**07V-268**  
**(18 pages)**

Subject: **Safety Recall – Steering U-Joint Assembly - New Flyer Part Number 8112157.**

**INSTRUCTION TO SERVICE ITS: 3306**

Figure 1:

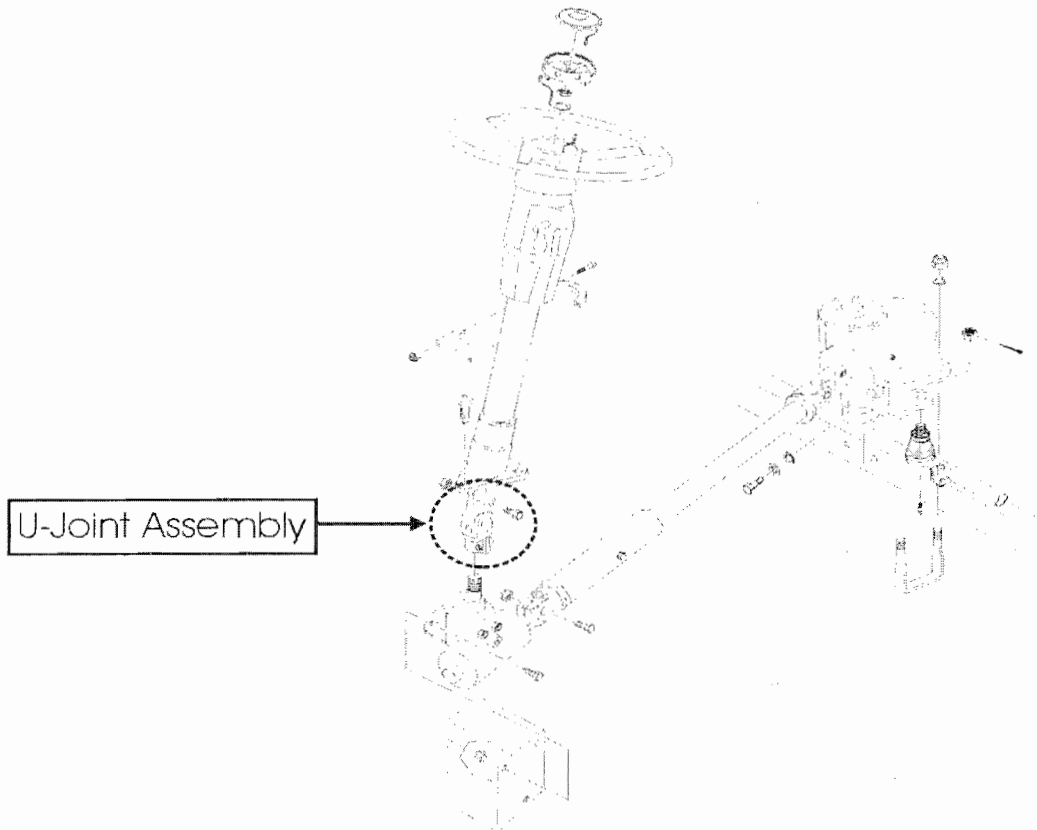
2. Locate U-Joint Assembly as shown in Figure 1.

Figure 3:

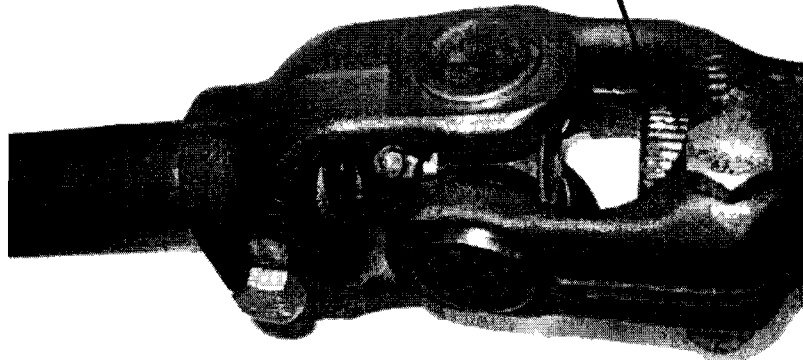
3. Inspect U-Joint Assembly. If either or both of the following are present, U-Joint Assembly must be replaced, otherwise skip to step 10:
  - a. "Spicer" logo stamped on the U-Joint. See Figure 2.
  - b. One splined shaft protruding  $\frac{1}{4}$ " or more beyond yoke housing at end where offset bolt is located. See Figure 3.

Shaft protruding into yoke housing

4. Install new U-Joint Assembly (PN 8112157) as required. Torque bolts between 30 to 35 ft-lbs.
5. Check for worn splines on the steering column and transfer gearbox by grasping the U-Joint Assembly by hand and twisting it back and forth.
6. If splined connection is too loose between steering column or transfer gearbox, replace components as required.
